MEMORANDUM

March 5th, 2014

SUBJECT: Public hearing and consideration of a Landmark Alteration Certificate to demolish a contributing accessory building and in its place construct a one-and-a-half story, 425 sq. ft., two-car garage at 730 Pine St. in the Mapleton Hill Historic District, per section 9-11-18 of the Boulder Revised Code (HIS2014-00027).

Figure 9. Existing (l) and proposed (r) site plans.

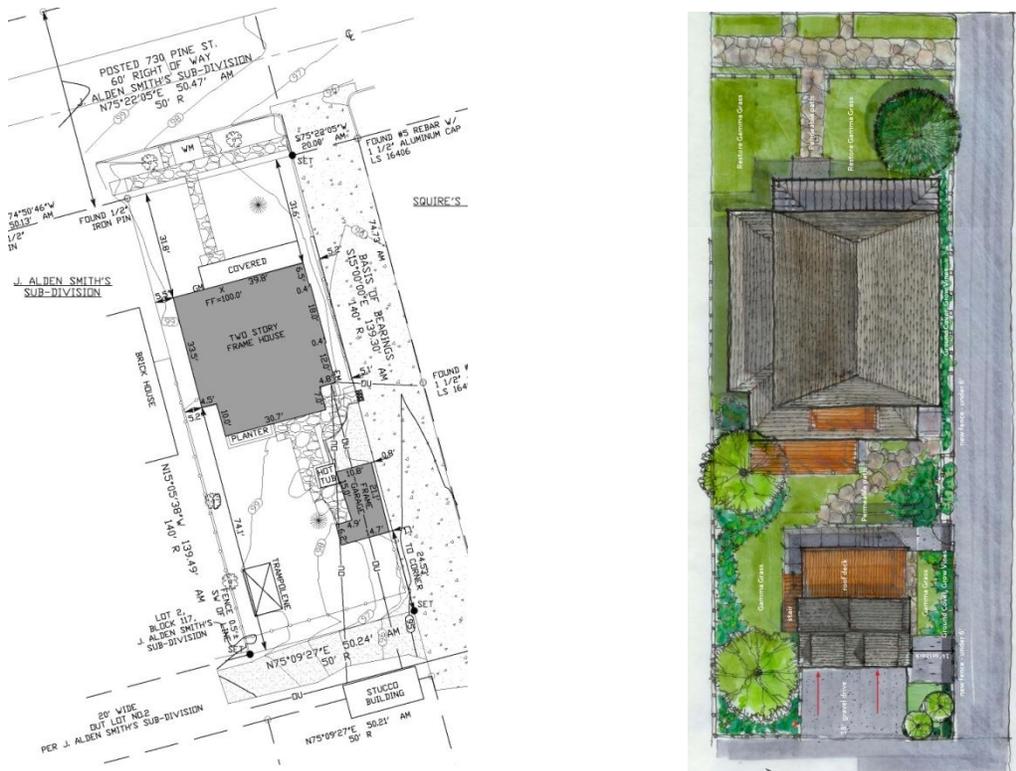
In plan, proposed garage measures 22'6 ft. by 21'1 ft. and is shown to be located toward the rear of the property, with access to the alley to the south. It is positioned 26'4 from the rear of the primary house, 14'4 from the west property line, 14' from the west property line (alley side) and 15'6 from the south property line (alley side). A rear deck, approved under a separate Landmark Alteration Certificate, it to be located at the rear of the primary house. Approximately 14' of landscaped area would separate the proposed garage and rear deck on the house, positioning the garage roughly in the center of the rear yard.
